Design Integrity Report

*45–53 Macleay Street, Potts
Point*

This Design Integrity Report has been prepared to accompany a detailed State Significant Development (SSD) Development Application for the shop-top housing (inclusive of 15% affordable housing) detailed design application at 45-53 Macleay Street, Potts Point (SSD-83867719). This detailed SSD follows the Concept SSDA (SSD-79316759).

Figure 1 – Extract of KHA Drawing No. A1010 Rev. A dated 12.11.2025

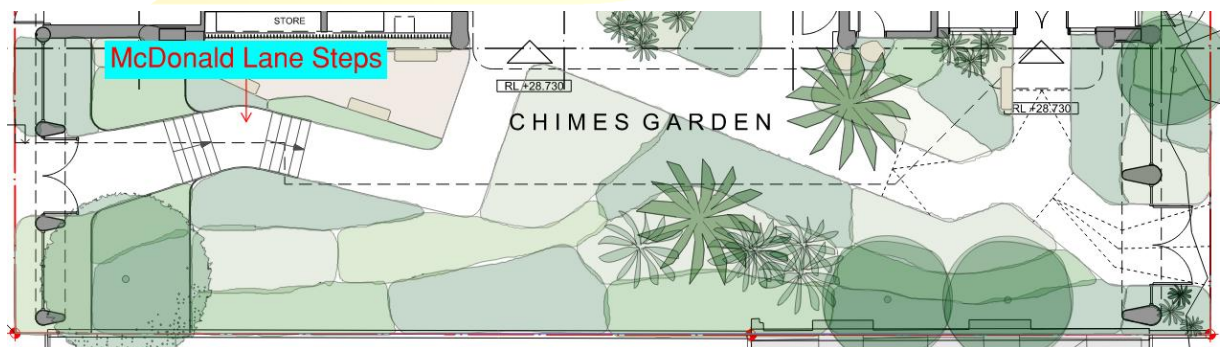
1.4 The Panel requested the Applicant provide DDA advice which confirms the accessibility of the McDonald Lane steps.	STAC Consulting have provided a letter (Appendix D) which confirms that a performance solution can be prepared to address the provision of steps off McDonald Lane rather than a ramp or lift and there are alternative DDA compliant access points to the lobbies.
Podium	2.1 The Panel requested confirmation that the podium circulation areas meet the definition of 'breezeway' for GFA purposes.	There is no formal definition of 'breezeway' in the Sydney LEP or the Standard Instrument. However, case law establishes that calculating GFA is based on whether or not a space is "enclosed on all sides by external walls or common walls" (<i>HPG Mosman Projects Pty Ltd v Mosman Municipal Council [2021] NSWLEC 1243</i>). The ends of the breezeway corridors would be open to improve natural ventilation to the studio apartments. Refer to the Design Report prepared for the SSDA package for further detail. Therefore, the podium circulation areas would be excluded from the total GFA calculations. This will be further assessed by the Department as part of the Detailed SSDA.

Prior to submitting the State Significant Development Application, it is understood the Applicant has been requested by the project Design Integrity Panel (DIP) to provide advice which confirms the accessibility of the McDonald Lane steps (refer to Figure 1 below).
